DESIGN/DEVELOPMENT REVIEW COMMISSION
DESIGN REVIEW DISTRICT
REGULAR AGENDA
EVALUATION SHEET
Case # 1

PROJECT NUMBER: DDRC-2025-0028

ADDRESS: 602, Huger Street, 603, 609, & 613 Pulaski Street, and Pulaski Street
(no name)

NATURE OF REQUEST: Request Certificate of Design Approval for the new construction of a mixed-use apartment complex

1 South Elevation (Blossom St.)
SCALE: 3/32" = 1'-0"

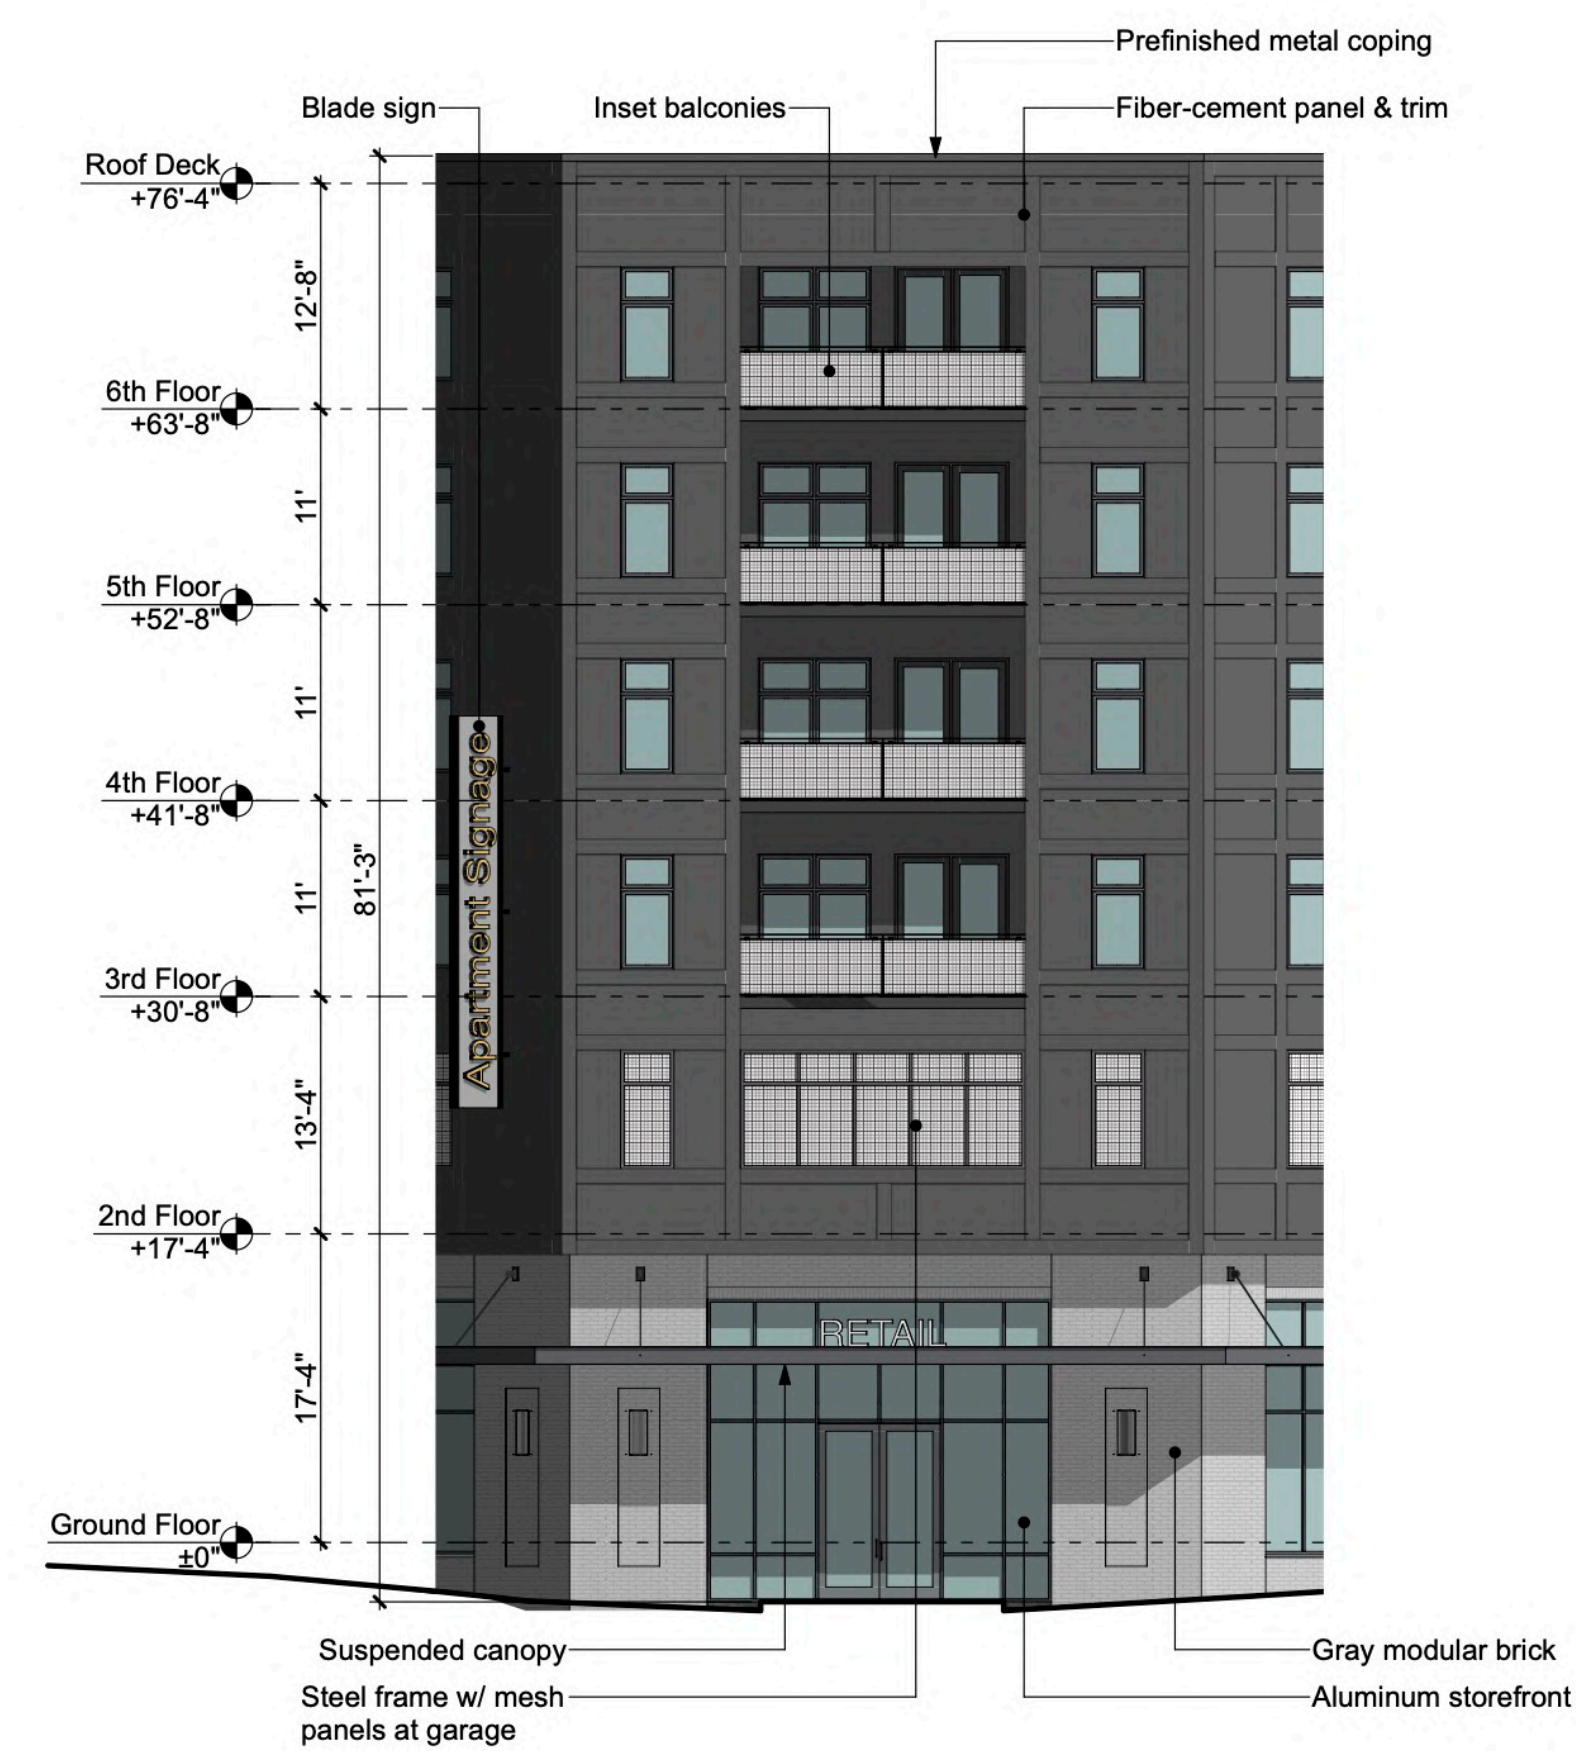
Blossom Street slopes significantly downward towards Huger Street. This grade change predominantly effects the Blossom Street façade and manifests in a stepping down of its ground floor openings. While the tops of these openings remain aligned, the window sill locations vary in height. Large variations in the gaps between the window sills and ground plane along this section of the Blossom Street façade create the impression that façade elements are not being appropriately stepped down.

Given the high visibility of this building frontage, staff finds that the bottoms of these openings should step down in a manner that is more proportionate with the slope of the site. In other words, a visual line should be drawn – starting at the first screened ground floor opening closest to Huger Street – that connects the bottom-right corners of these openings across the grade change. The applicant shall coordinate with staff on the alignment of these openings.

Further articulation and ornamentation of the building facades is needed to divide the building into more pedestrian-scaled sections. Better distinguishing the ground floor from upper-stories – through the use of additional awnings or horizontal expression lines – along the majority of the Blossom Street façade and a section of the Pulaski Street Facade will help achieve this. So will creating more distinct horizontal layers – through ornamentation, changes in materiality, and variations in surface depth – within the expanse of the five stories that sit atop the Blossom Street façade’s base.

The proposed development's longest façade – the Blossom Street façade – is broken down into four bays that are marked by variations in the depth of the outer-most surface. Adding greater variety to the heights of these four bays, particularly of the corner bays clad in grey, fiber cement siding, will help break up the monolithic street wall of the Blossom Street façade.

- Coordinate with One Columbia for Arts and Culture in the commissioning of those murals.
- Better align the bottoms of the ground-floor openings along the Blossom Street Façade to be proportionate with the slope of the ground plane.

- Add vertical articulation to the Blossom Street façade through varying the heights of that façade's four bays – particularly the corner bays that are clad in fiber cement panels.

4 Concrete Block
EL.03 NOT TO SCALE

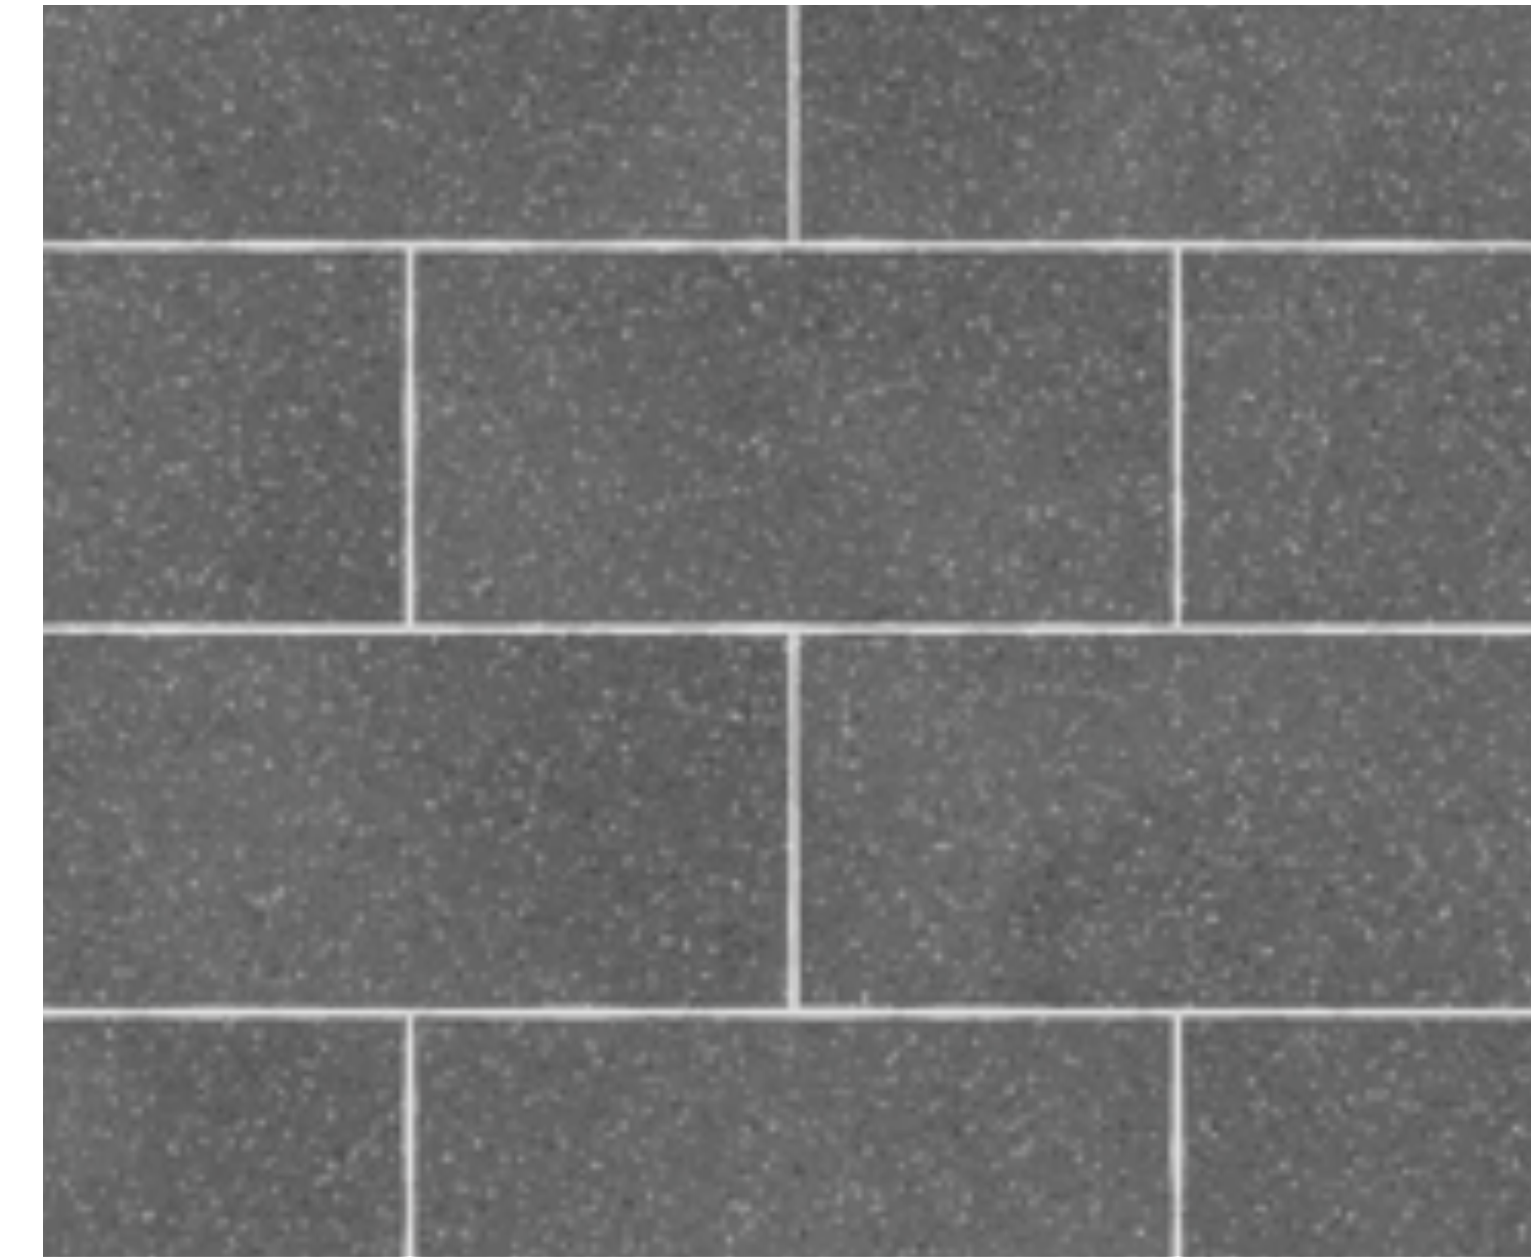
The lower levels of the northern face of the building, which runs through the interior of the site, is partially clad in concrete block. Given the low-slung nature of the neighboring structures immediately north of the site, it's possible that this exposed concrete block will be

visible from the right-of-way. Staff recommends that the applicant coordinate with staff on exploring alternative cladding materials on these lower levels based on rendering studies of this façade's visibility from Pulaski Street and Huger Street.

- Study the building approach heading west from the Blossom Street Bridge to determine if more screening of roof-mounted equipment is necessary.
- Explore alternative cladding materials on the base of the North Elevation based on visibility from Huger and Pulaski Streets.

5 Window Detail at Fiber-Cement Siding
EL.03 SCALE: 3/4" = 1'-0"

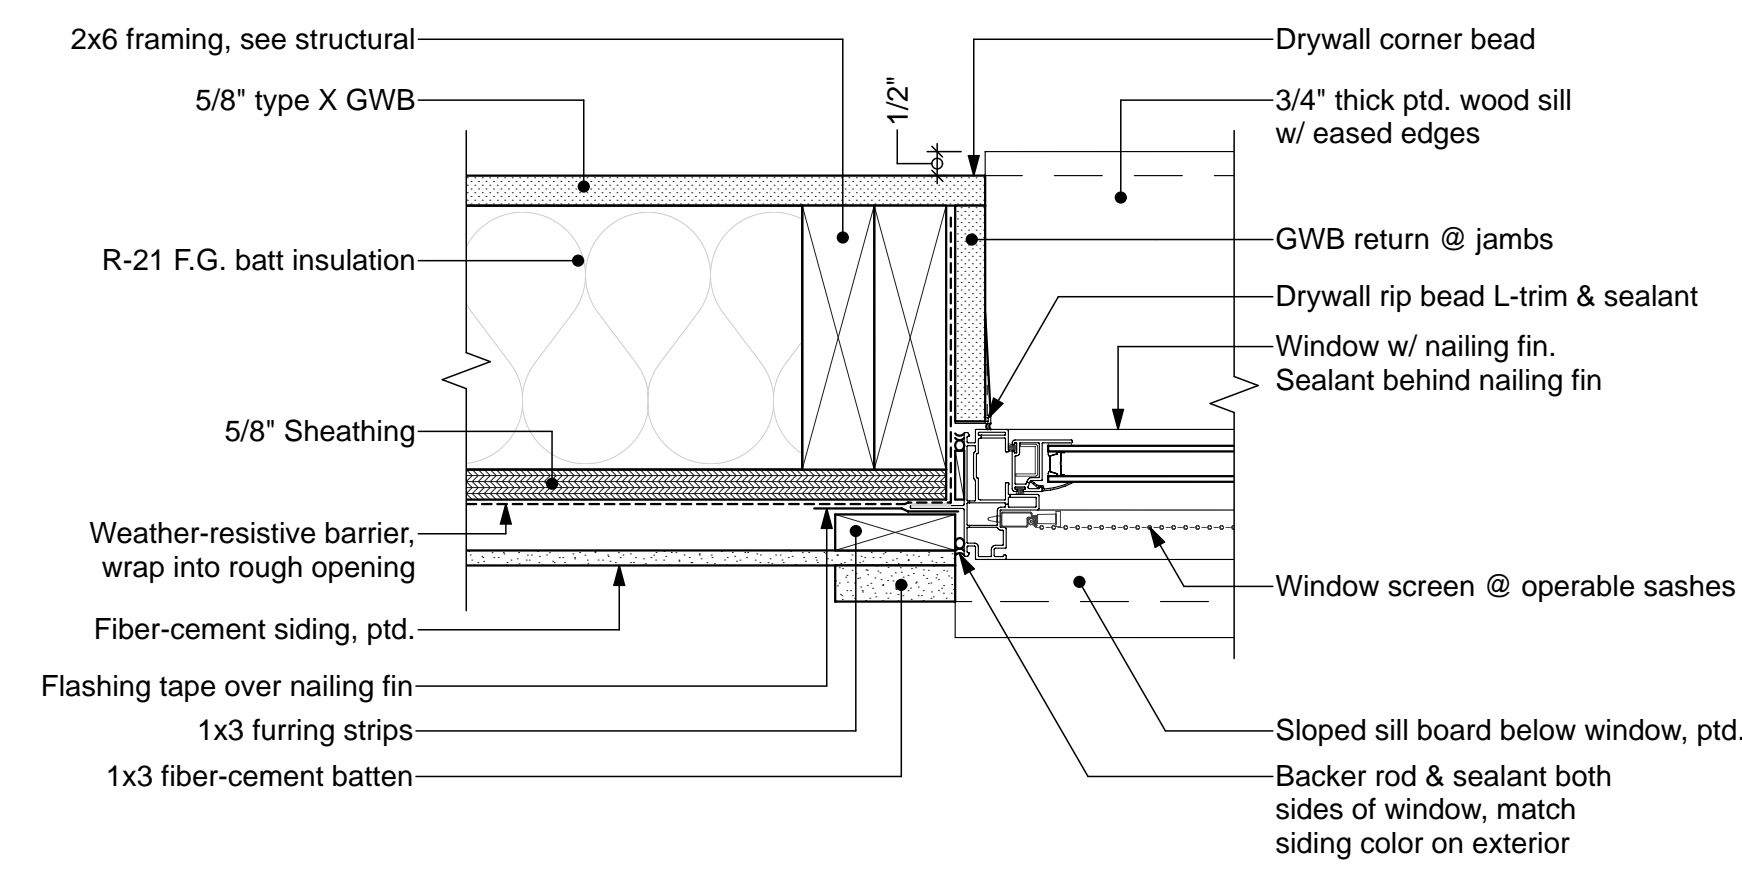
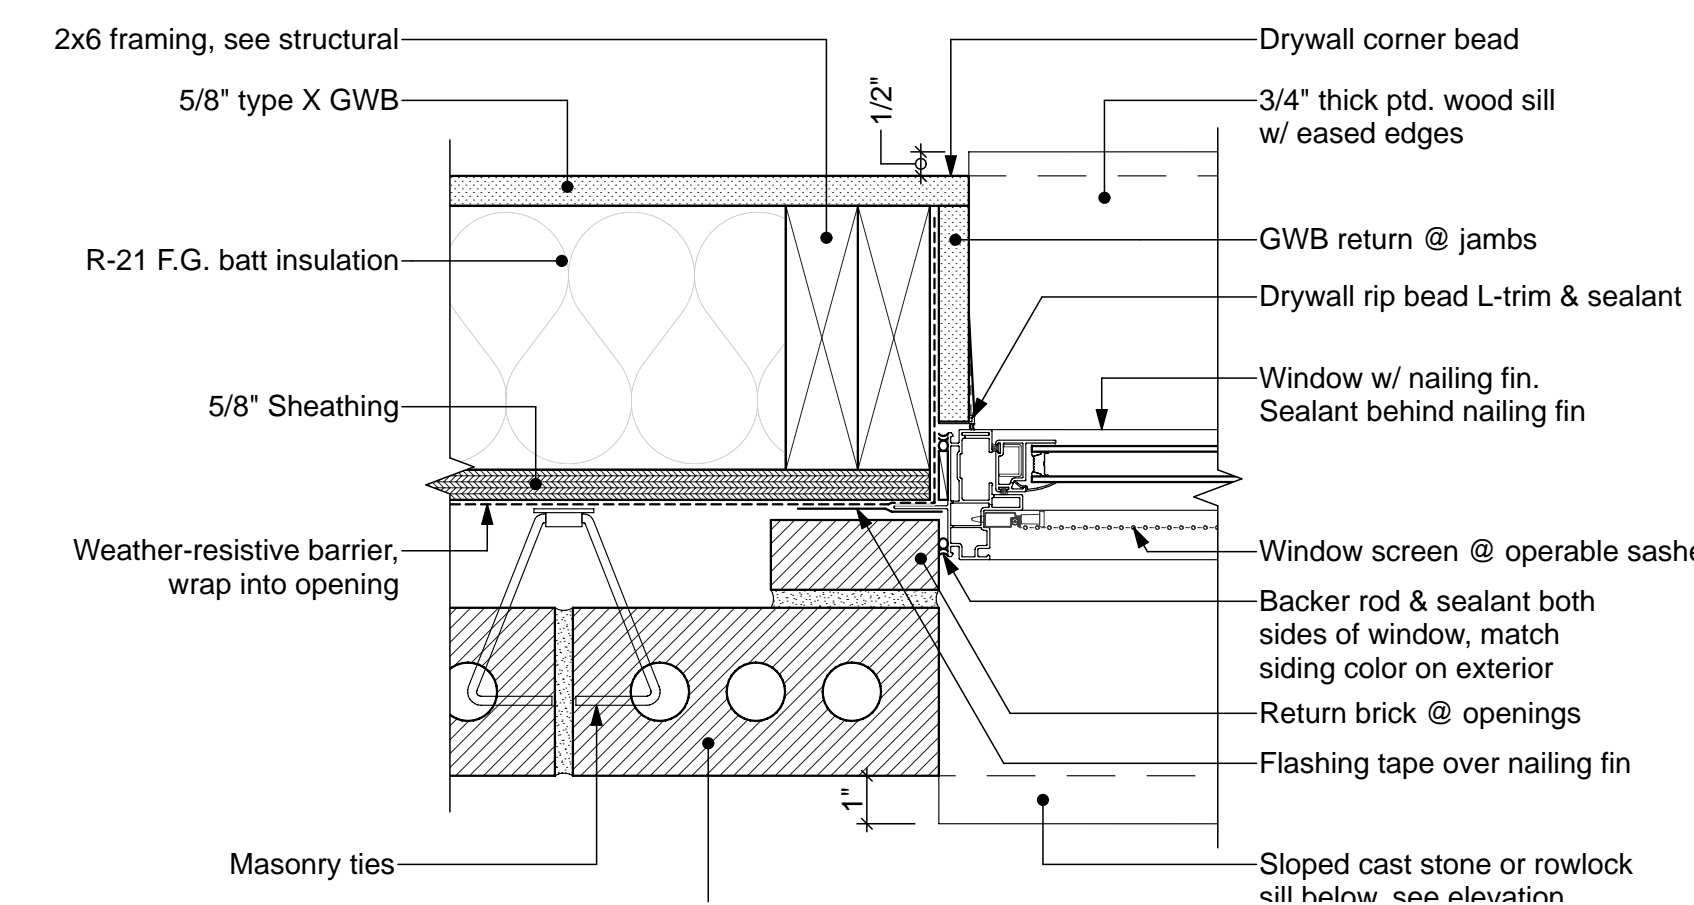
Staff finds that upper-story windows appear lacking in depth and recommends that the applicant coordinate with staff on increasing window jamb depth. Doing so will help reduce the appearance of upper-story windows that are flush with the siding material. The addition of small metal sun shades or fins above upper-story windows would also add articulation and visual interest to the upper façade.

- Coordinate with staff on further articulating the upper-story windows through deepening the window jambs or adding small sun shades.
- Signage must come back for separate review
